Re: Petition No. 1533 - ReNew Developers, LLC petition for a declaratory ruling, pursuant to Connecticut General Statutes §4-176 and §16-50k, for the proposed construction, maintenance and operation of a customer-side 4.99-megawatt fuel cell facility and associated equipment to be located at 42 Old Amston Road, Colchester, Connecticut.

Enclosed for filing with the Connecticut Siting Council ("Council") are ReNew Developers, LLC's responses to the Council's first set of interrogatories dated August 25, 2022.

CONCEPTUAL DEVELOPMENT PLAN  
 PROJECT TITLE: MAP 6/BLOCK 6/LOT 17  
 OLD HARTSON ROAD  
 PREPARED FOR: Peter Carli  
 14 Chestnut Hill Road  
 Colchester, CT

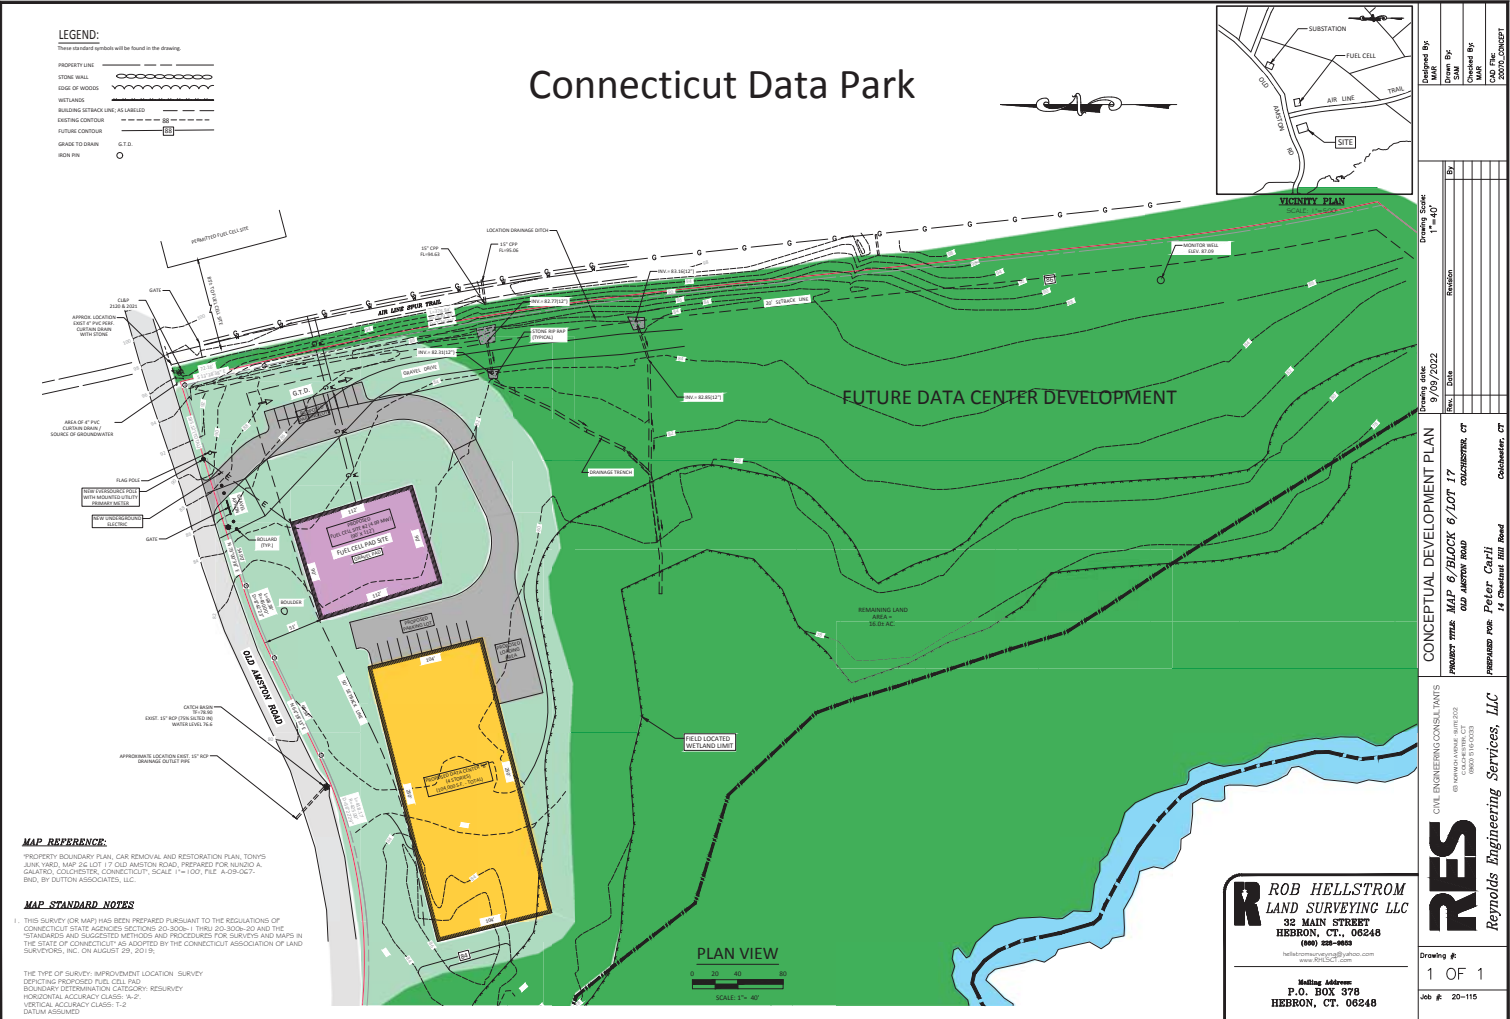
Q-CSC-7: Provide site plans showing the location of the data center in relation to the proposed fuel cell facility.

A-CSC-7: Site plans depicting the location of the data center relative to the proposed fuel cell facility are attached. See Exhibit CSC 7-1.
